REVISION: OVERSIGHT CONCERN - DATED FEBRUARY 23RD, 2022
SHEETS: A102, A103, A105, A200, A201, A203, A204, A300, A4.03

NO.	DESCRIPTION	DATE
1	REVISED AS PER CITY COMMENTS - DP	2021-10-27
2	OVERSIGHT COMMENTS	2022-02-23

364 E 14TH STREET
DUPLEX INFILL
COVER SHEET

AREA CALCULATIONS (G.F.A.)

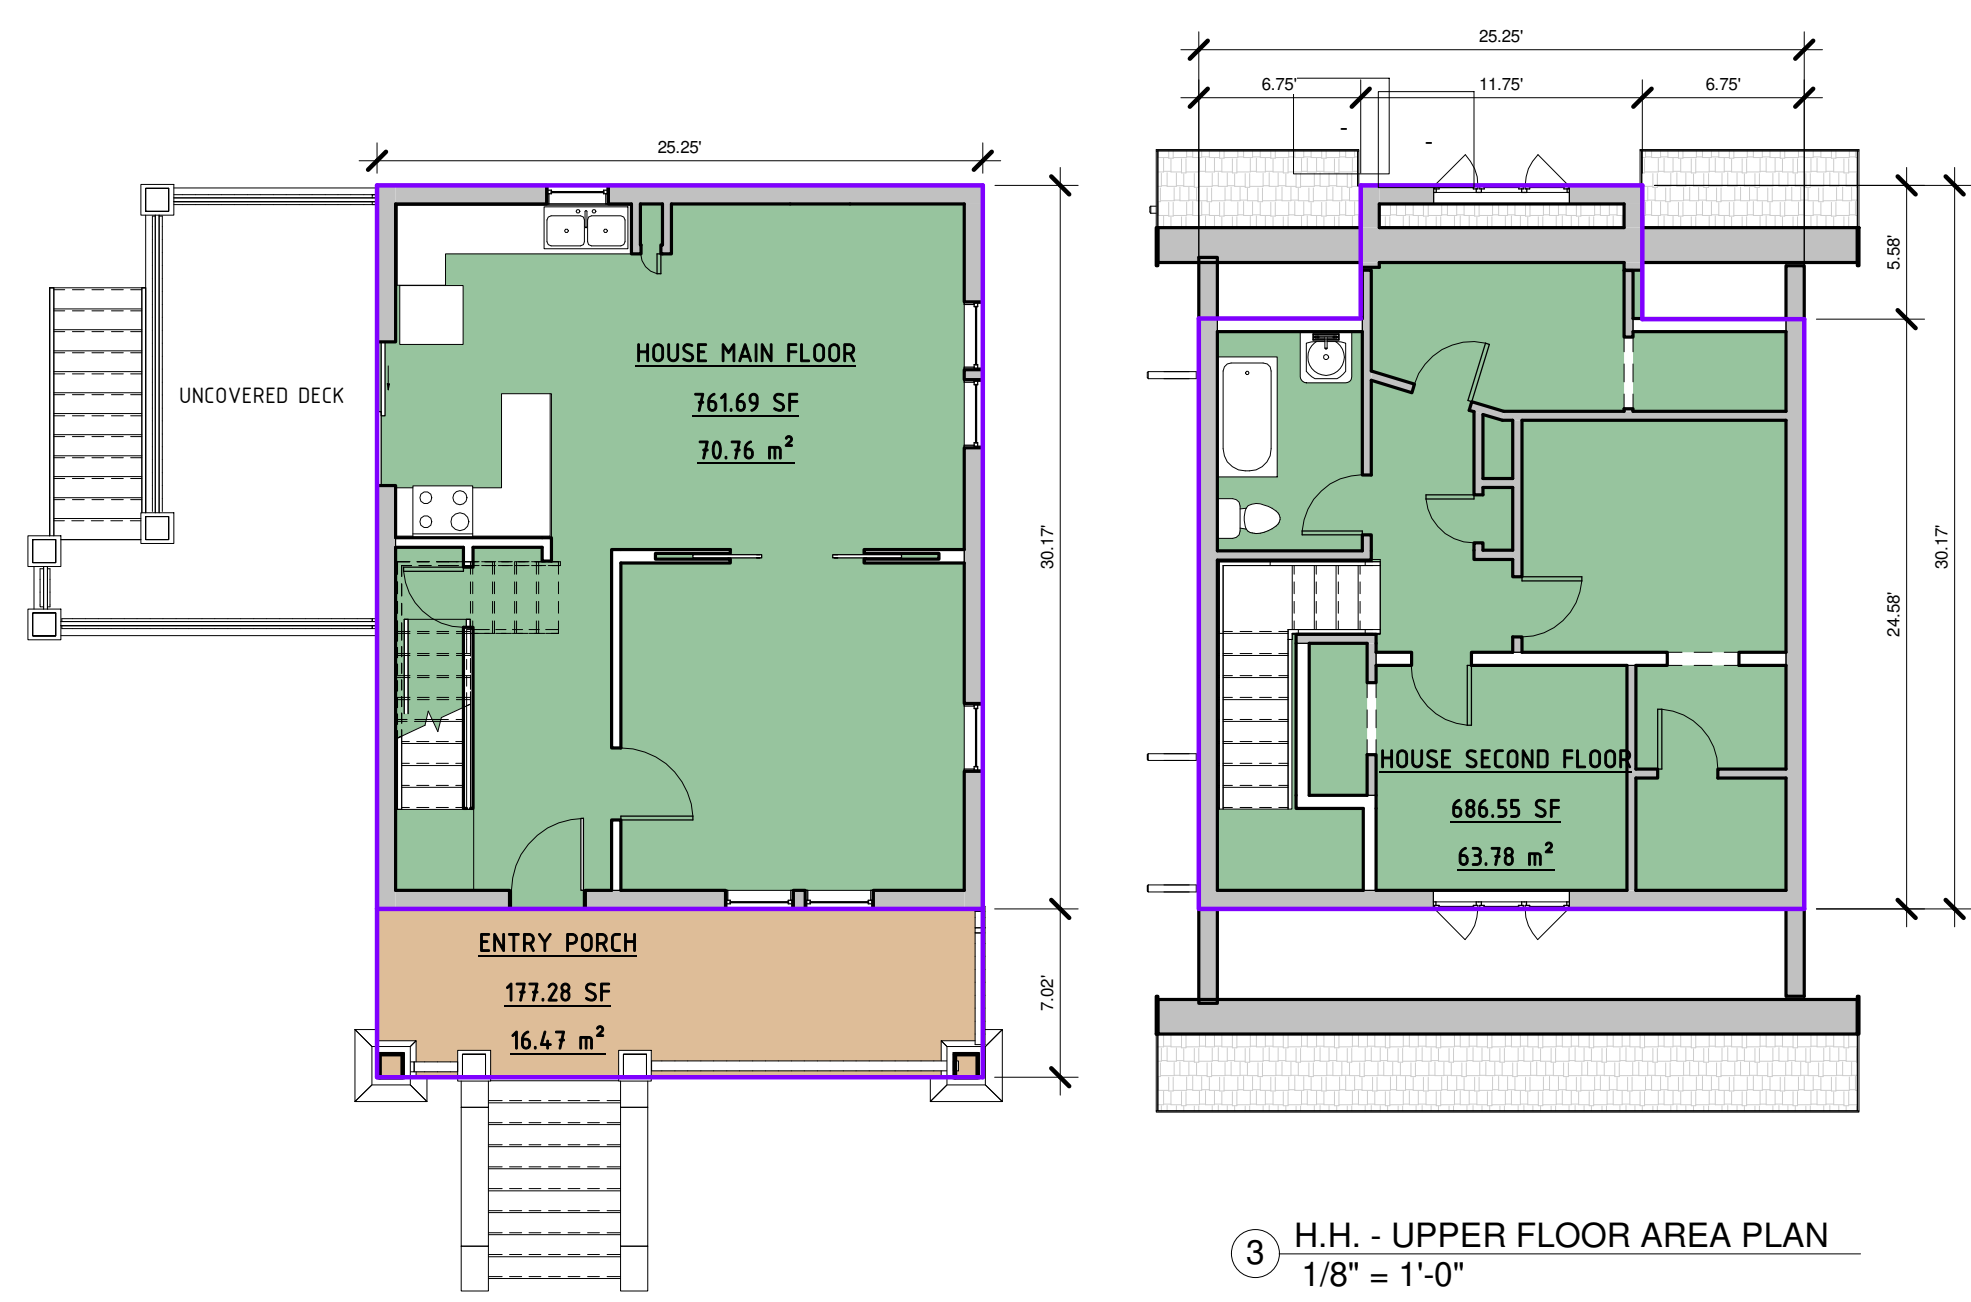
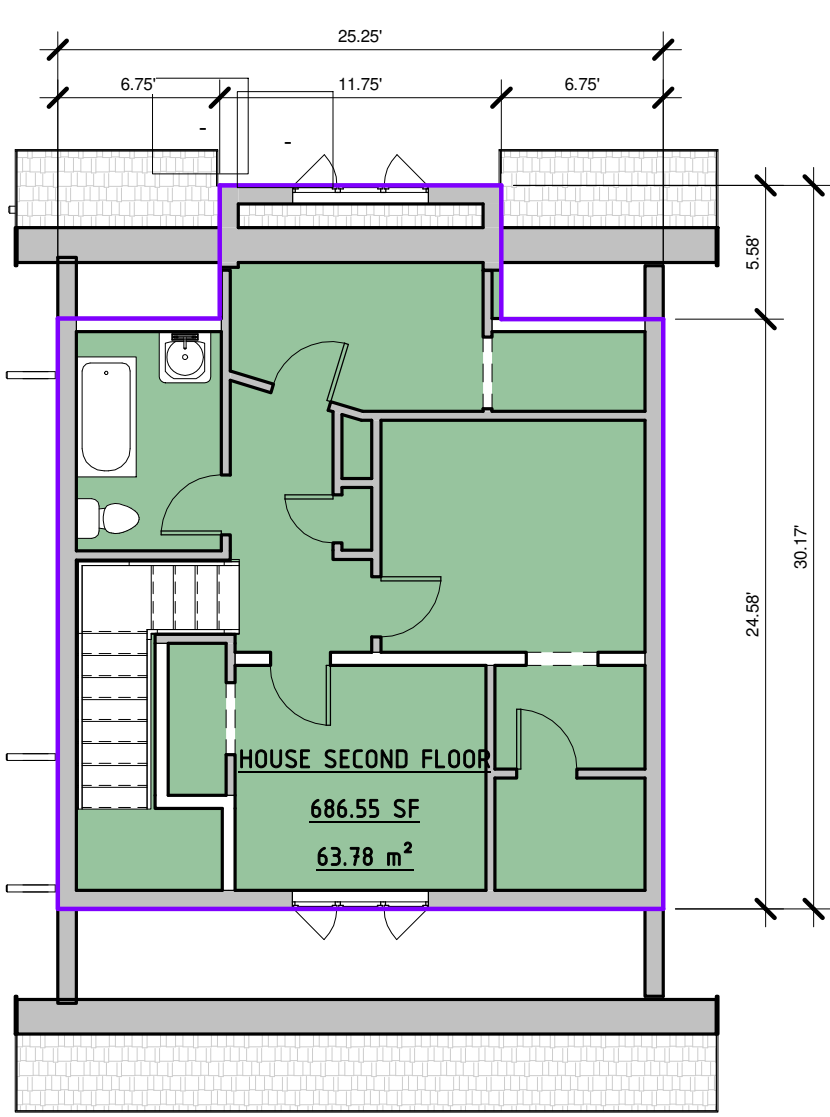
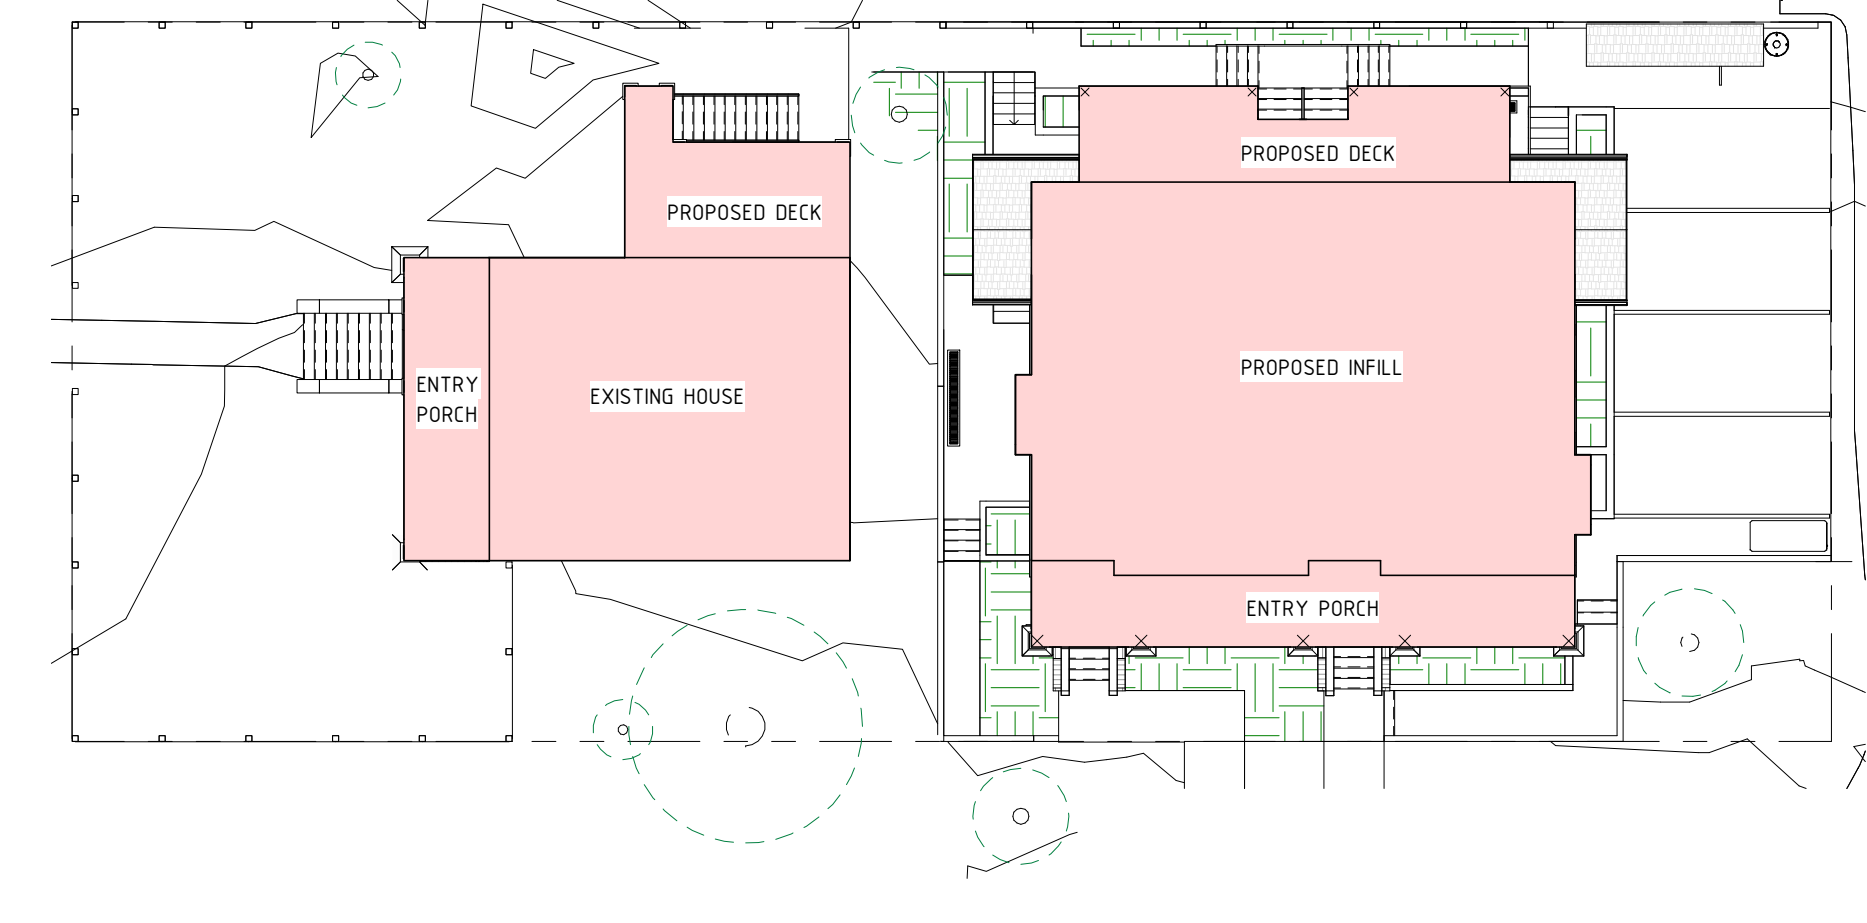
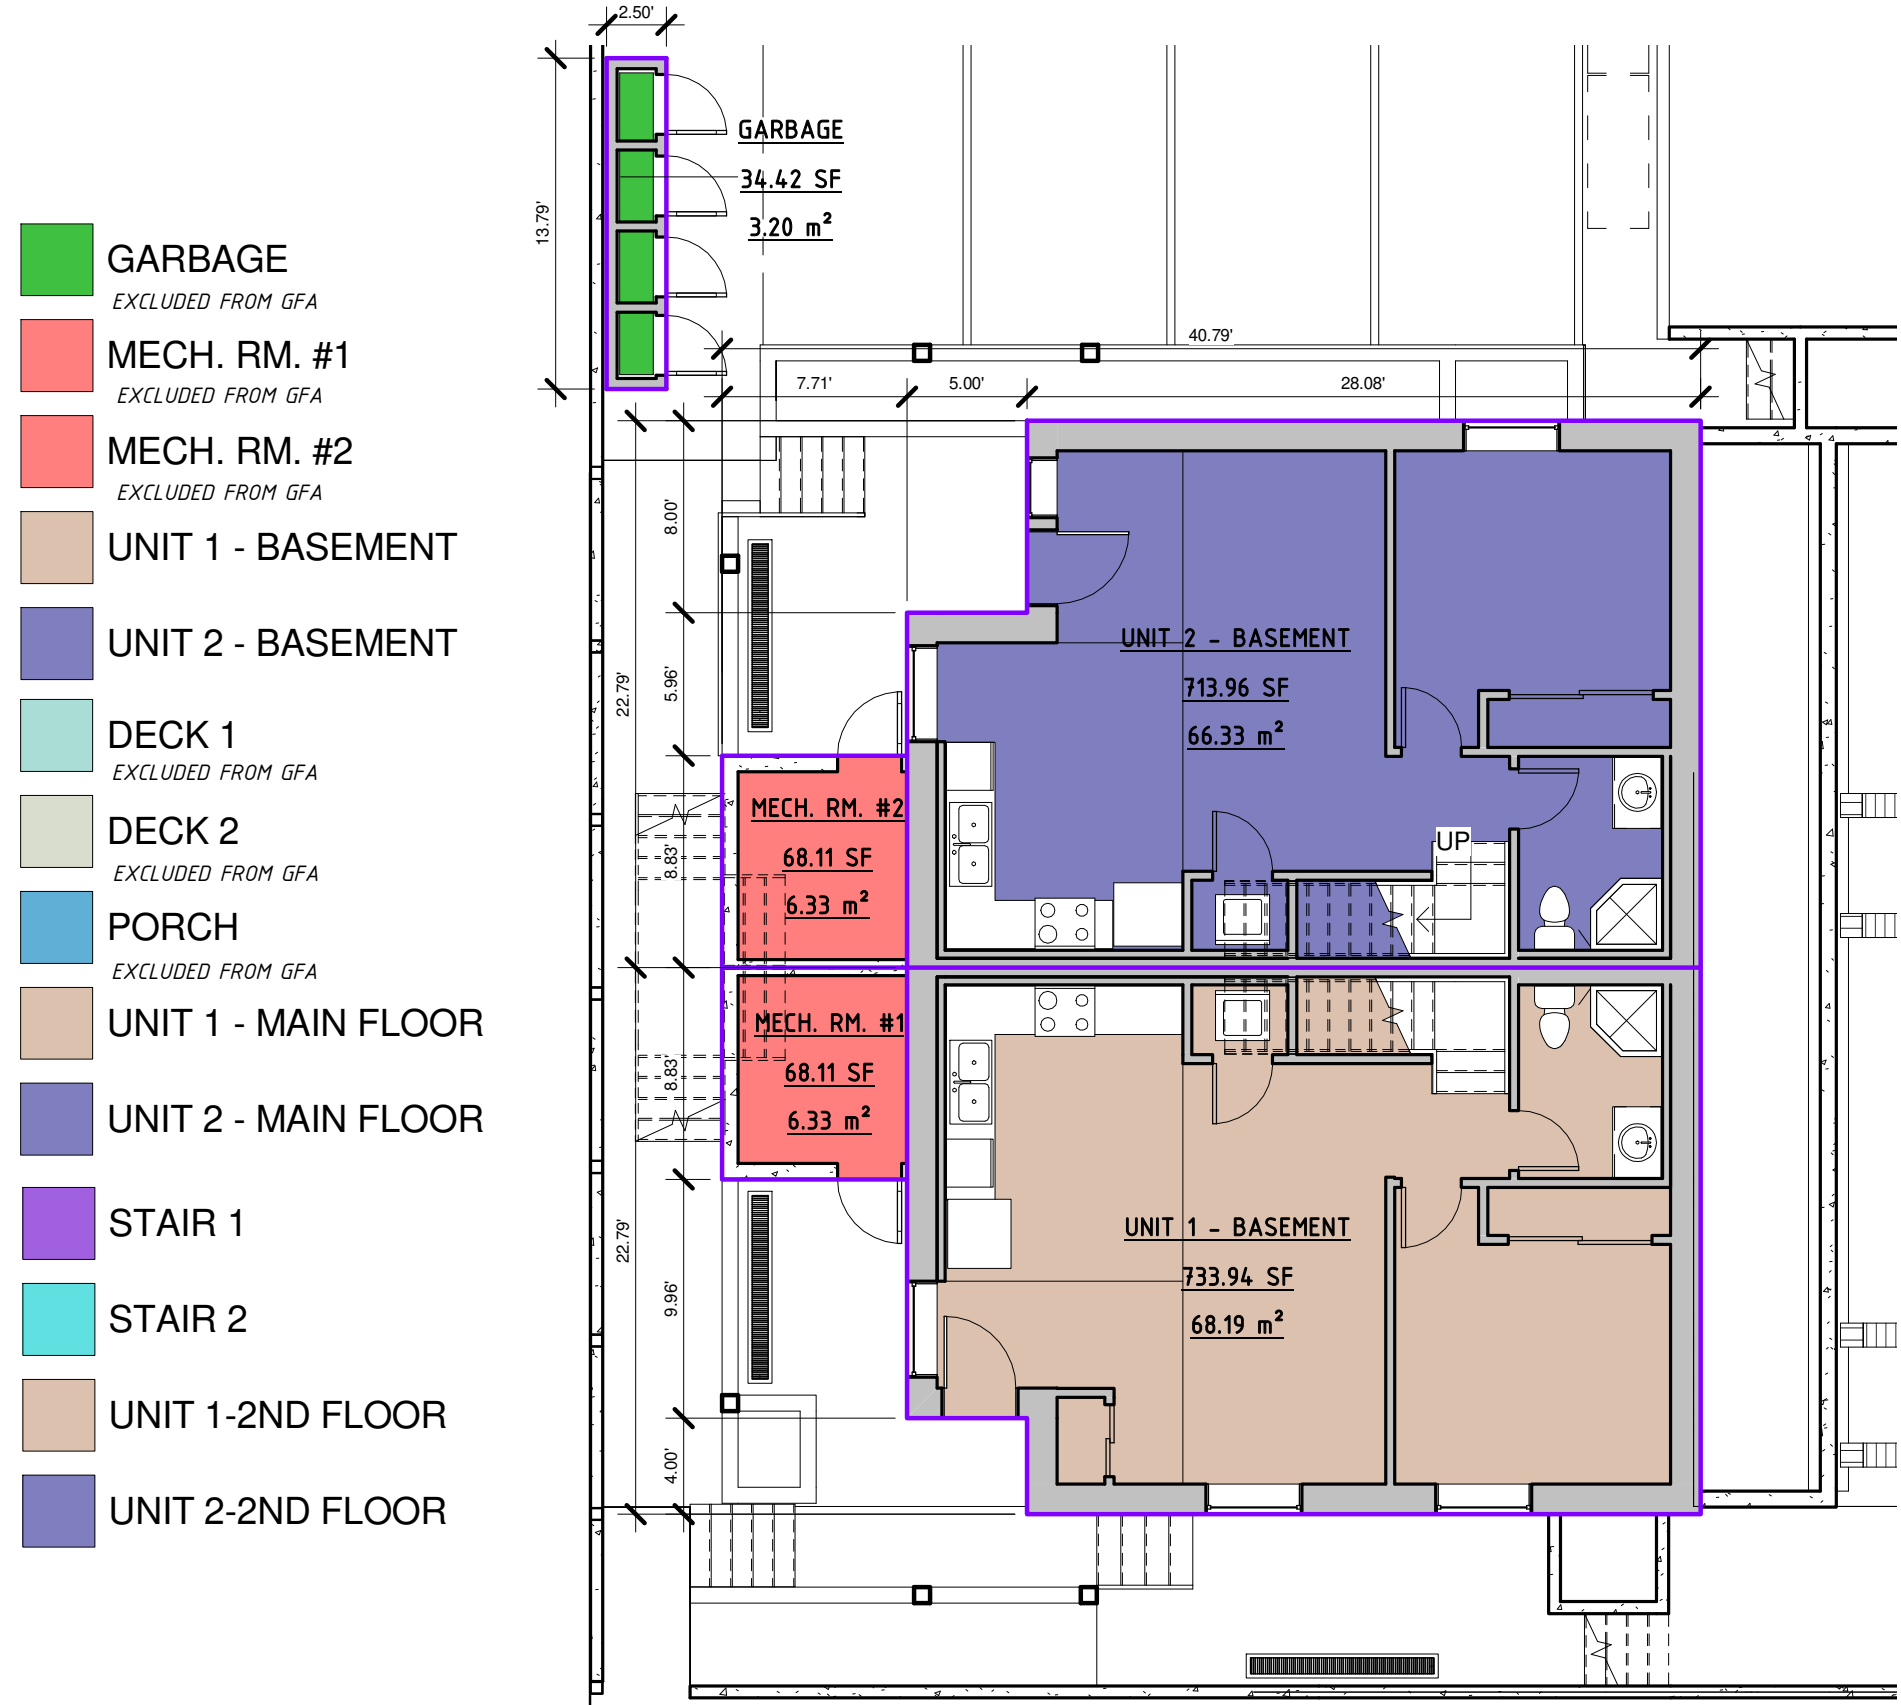
REVISIONS:
1 UPPER FLOOR AREA PLAN & CALCULATIONS UPDATED AS PER LAYOUT CHANGES
